**RE: 2618 N MILWAUKEE AVE
PROPOSED EXTERIOR ALTERATIONS –
LOGAN SQUARE BOULEVARDS DISTRICT**

Re: Grace's Furniture Building Redevelopment
2618 N Milwaukee Ave., Chicago, IL 60647
Architectural Review

Review Comments
Logan Square Preservation
August 30, 2019

LOGAN SQUARE HOTEL
K2 **K2 STUDIO**
329 W. 18TH #501, CHICAGO IL. 60616
P: 312.275.5000E: STUDIO@K2ARCH.COM

PROPOSED BUILDING
SITE RENDERING 1
SCALE: NTS

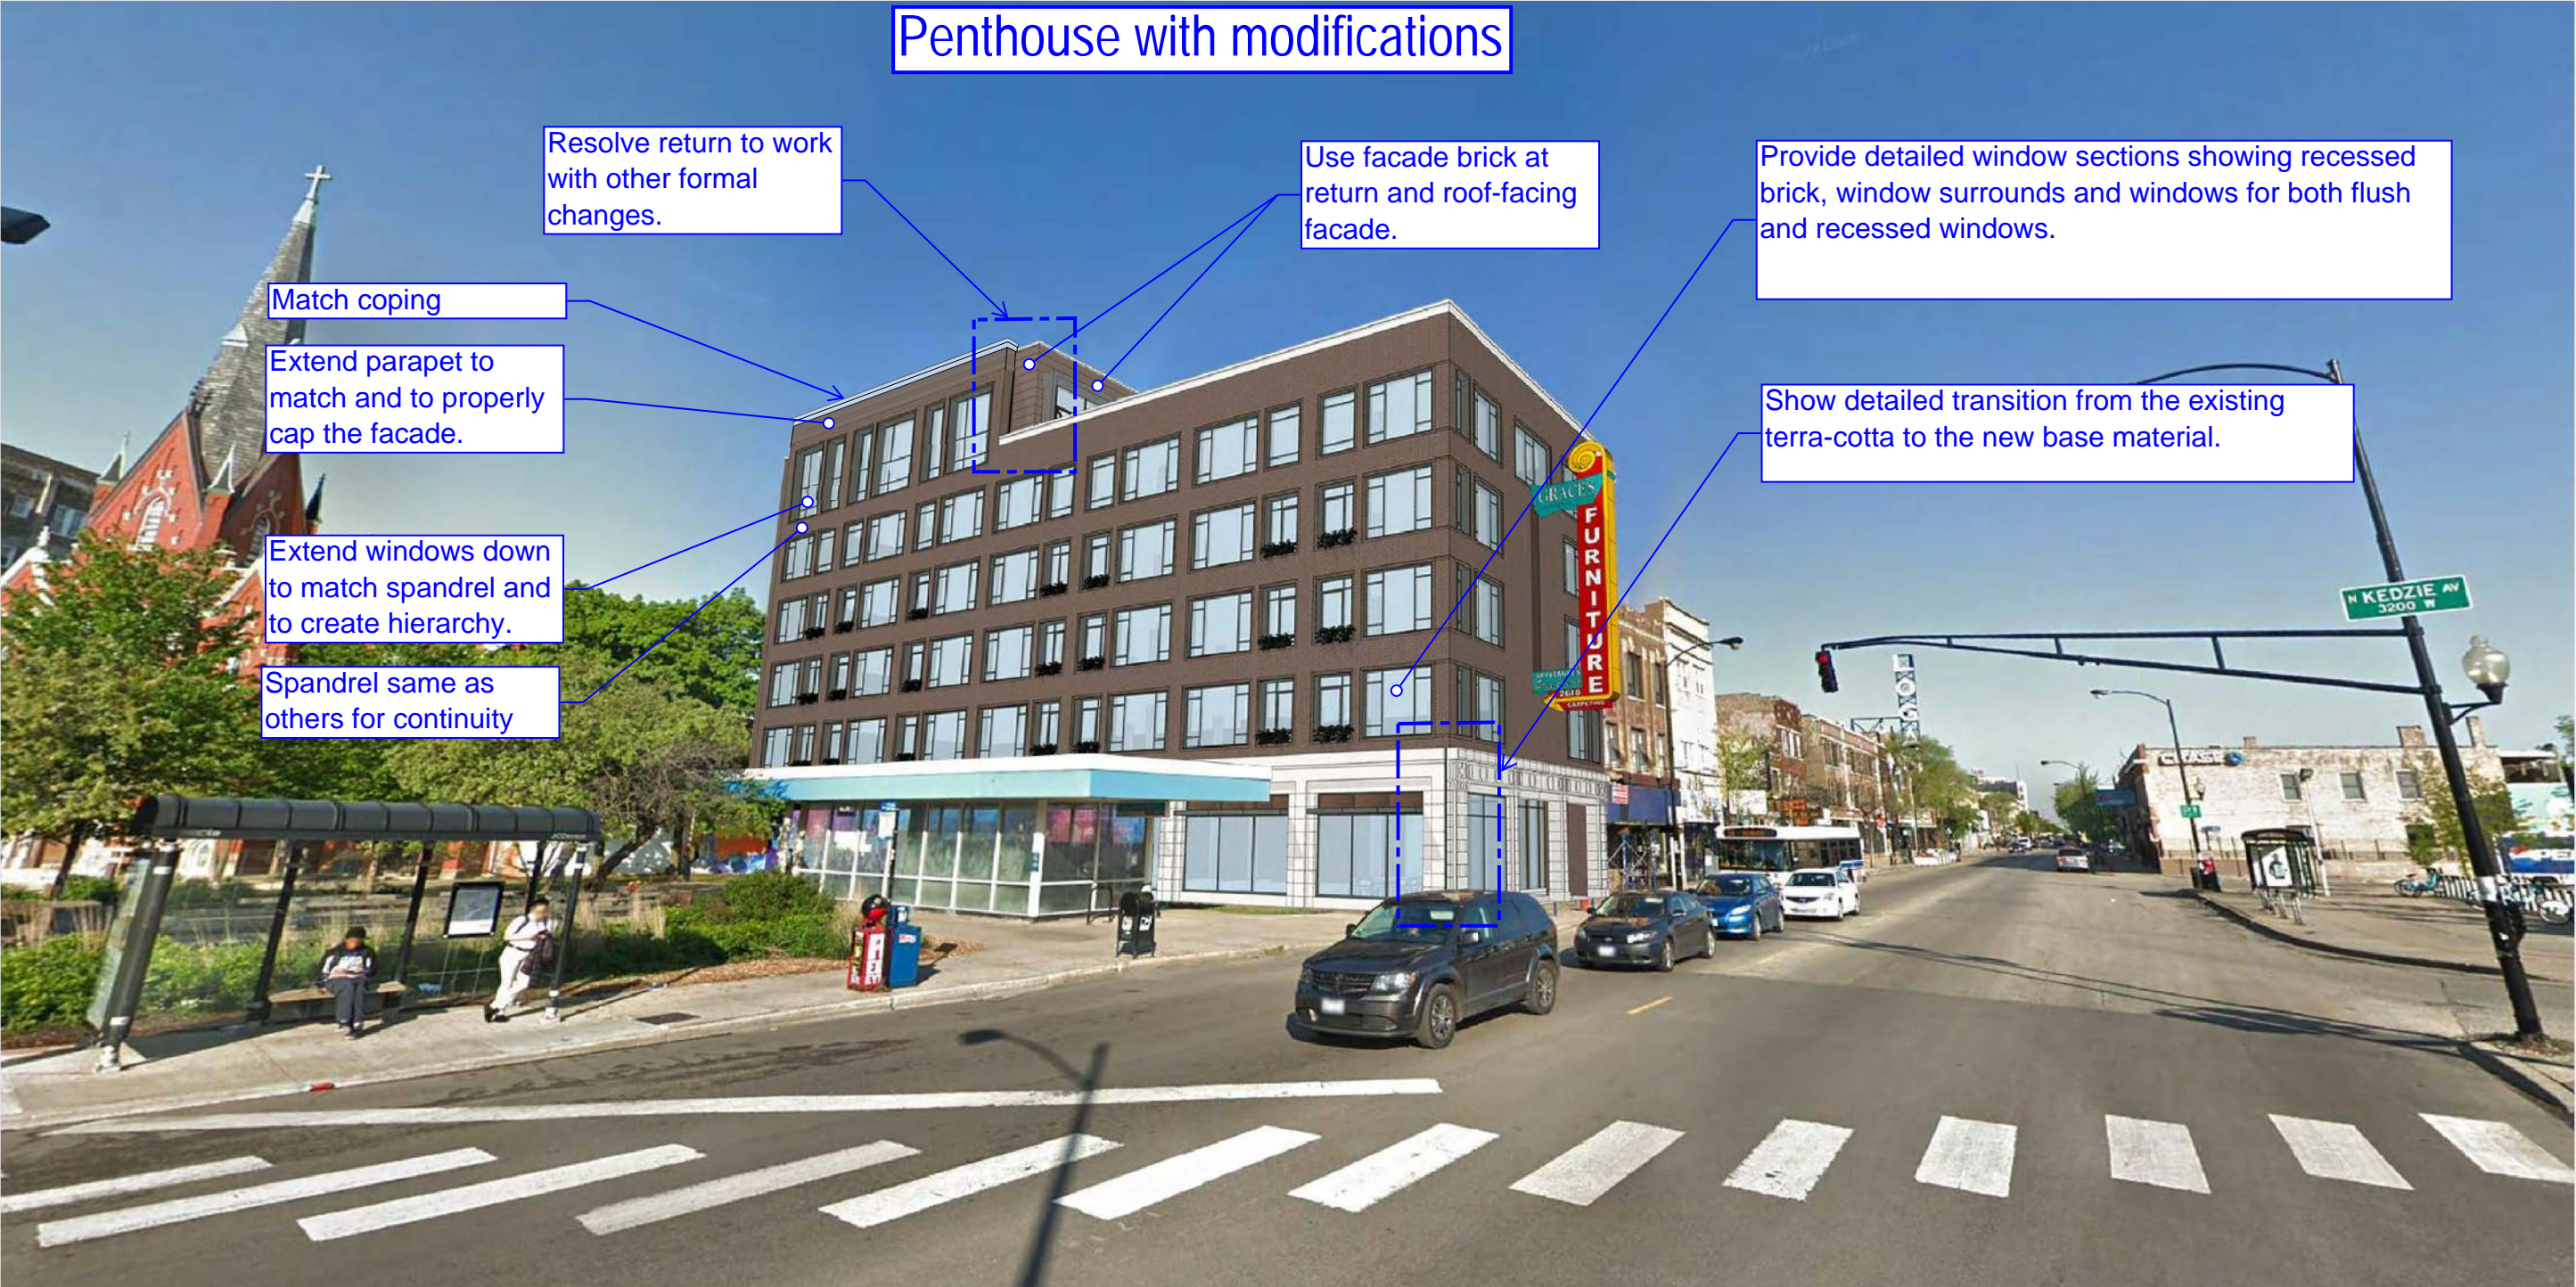
Consider decorative brick detailing in this central bay similar to other similar historical conditions, I.e., soldier course with recessed infill.

Provide brick articulation here using the recessed brick at other areas of the facade. Consider changing brick coursing pattern.

Consider counting recessed brick banding to maintain grid.

Consider accent detailing to match similar buildings with blank facade areas.

Show any proposed canopies, lighting and signage.

PROPOSED BUILDING
SITE RENDERING 2
SCALE: NTS

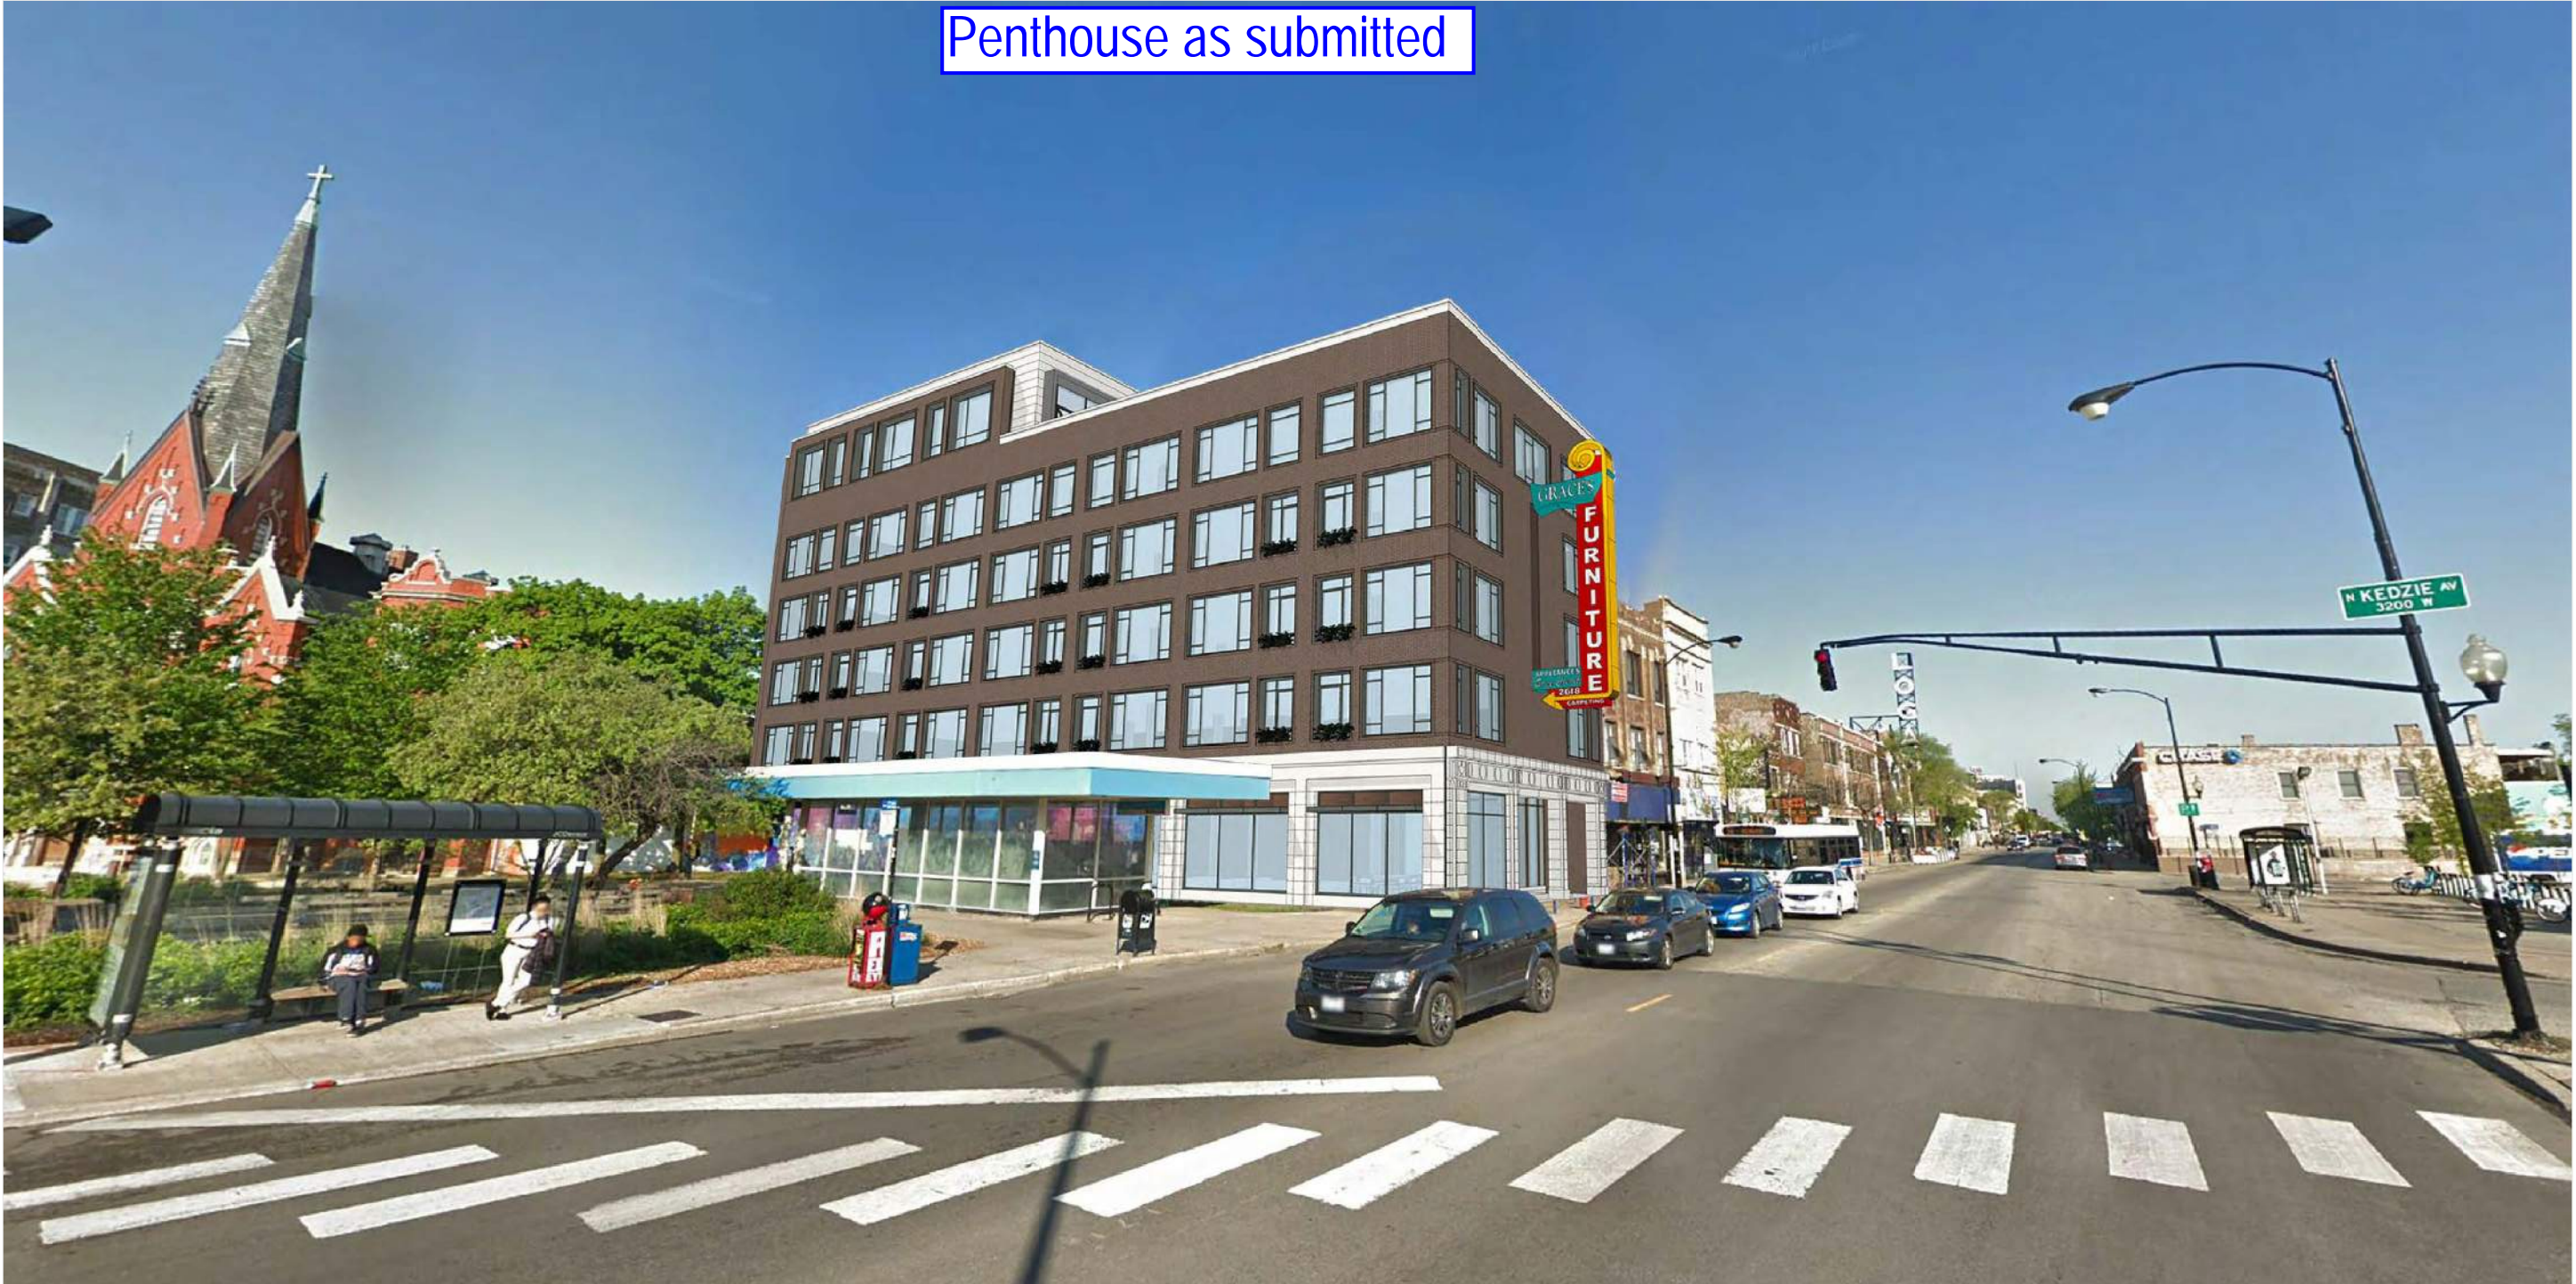
Penthouse with modifications

Resolve return to work with other formal changes.

Use facade brick at return and roof-facing facade.

Provide detailed window sections showing recessed brick, window surrounds and windows for both flush and recessed windows.

Show detailed transition from the existing terra-cotta to the new base material.

Match coping

Extend parapet to match and to properly cap the facade.

Extend windows down to match spandrel and to create hierarchy.

Spandrel same as others for continuity

RENDERING AT BUILDING
SOUTHEAST CORNER
SCALE: NTS

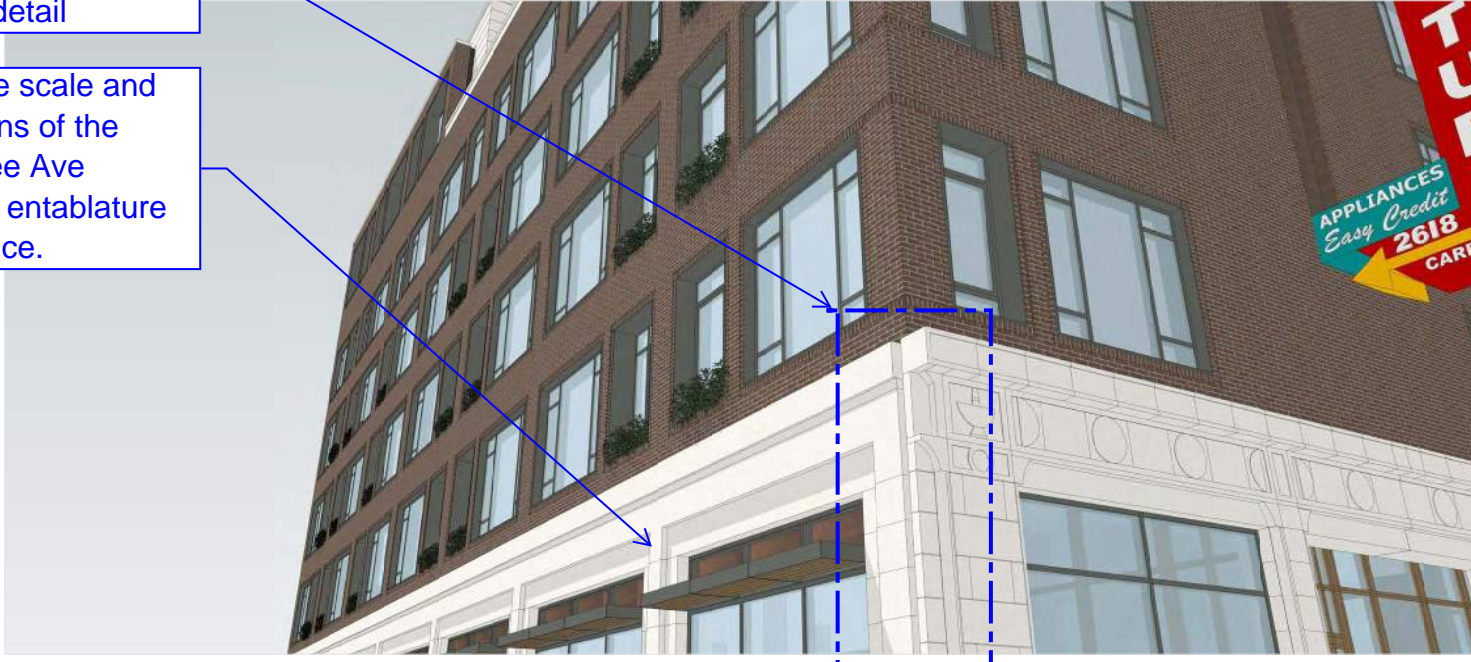
Show the transition
between the existing
historic and new terra
cotta in detail

Match the scale and
proportions of the
Milwaukee Ave
columns, entablature
and cornice.
